Re: **Grandview Subdivision (Amended)**

MDP# 800-A

The City Staff Development Review Committee has reviewed **Grandview Subdivision (Amendment)** Master Development Plan **M.D.P.# 800-A**, please find enclosed a signed copy for your files. Your plan was accepted however please note the following:

AMENDMENT TO GRANDVIEW SUBDIVISION MASTER DEVELOPMENT PLAN

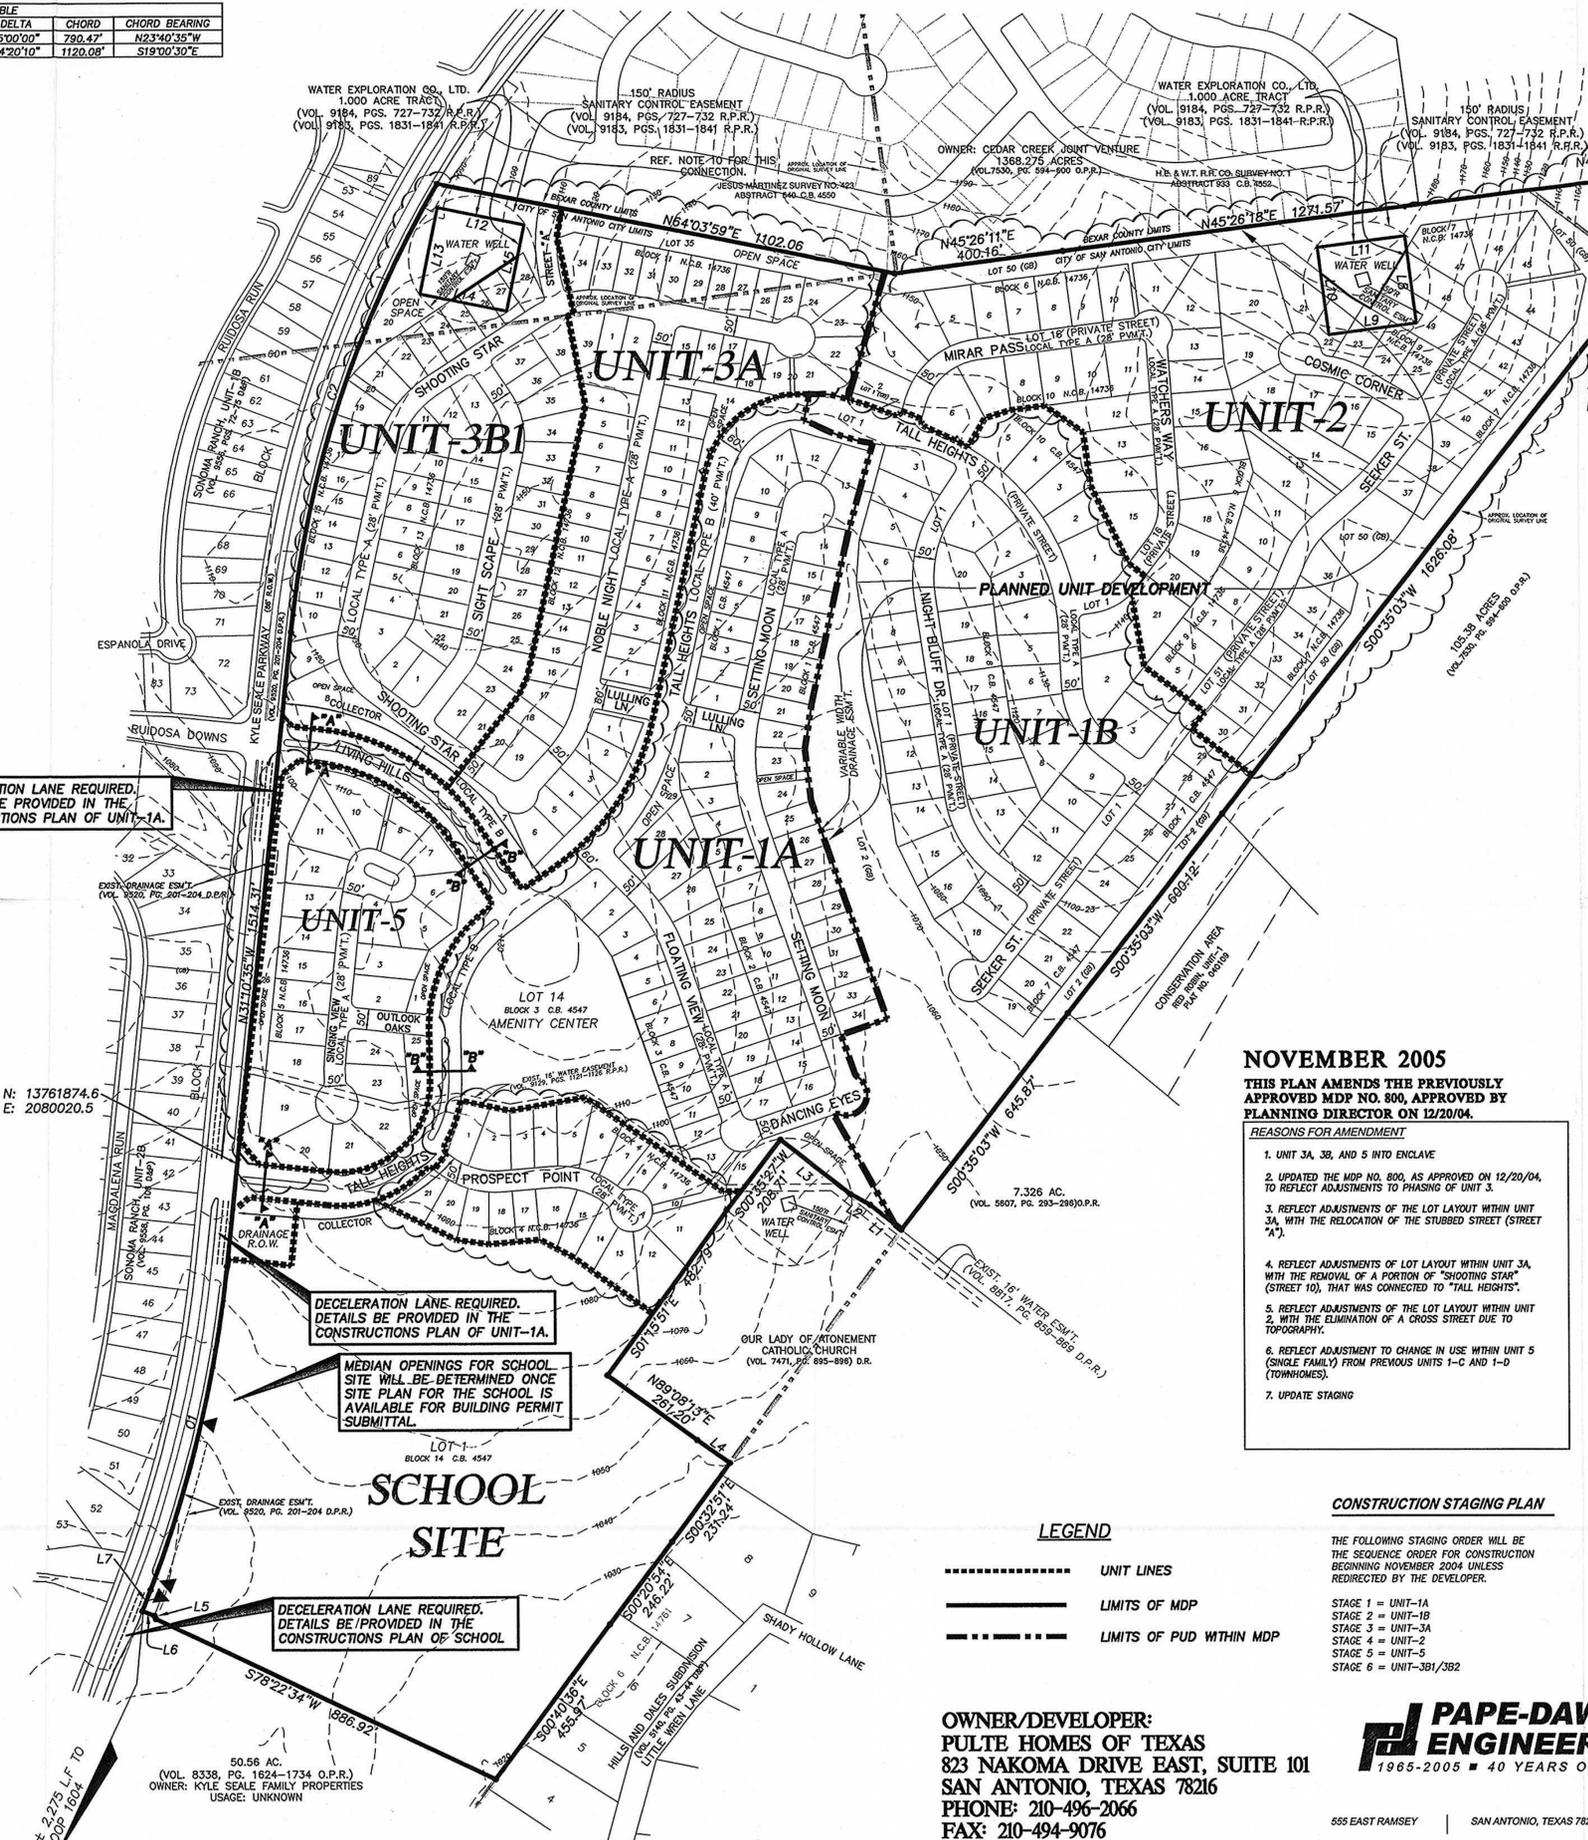
- In consideration of public safety and convenience, excessive grades by reason of topography should be avoided in street layouts and arrangements.
- Any access and R.O.W. issues along state facilities will need to be resolved with the **Texas Department of Transportation (TXDOT)**. For information about these requirements you can contact TXDOT at 615-5814.
- **SAWS Aquifer Protection and Evaluation** will require the following pursuant to the Aquifer Protection Ordinance No. 81491, for Plat Certification.
 1. 100 year Flood Plain Shown and Buffering (if applicable)
 2. Sensitive Recharge Features and Buffering (if applicable)
 3. Category Letter for All Site Specific Plats (if Category 2 or 3, an Aquifer Protection Plan is required)
 4. According to the Water Quality Ordinance # 81491, Section 34-913, buffering may be required.

Additionally, a Water Pollution Abatement Plan must be submitted and approved with the Texas Commission on Environmental Quality (TCEQ) prior to construction.

- **Bexar County Public Works** has indicated as part of their conditional approval, the following conditions shall be met:
- It is understood that this MDP is a conceptual plan and all regulations will be addressed at time of platting.
- 2. Bexar County reserves the right to address Driveways, Street Design, Sight Distance, ADA requirements, Drainage and Flood Plain issues at the time of platting.
- It will be expected that you will plat all of the property depicted in your Master Development Plan (M.D.P.), to include floodplains, drainage areas and open space.
- I would encourage you to work closely with the school district, so that they can plan accordingly.
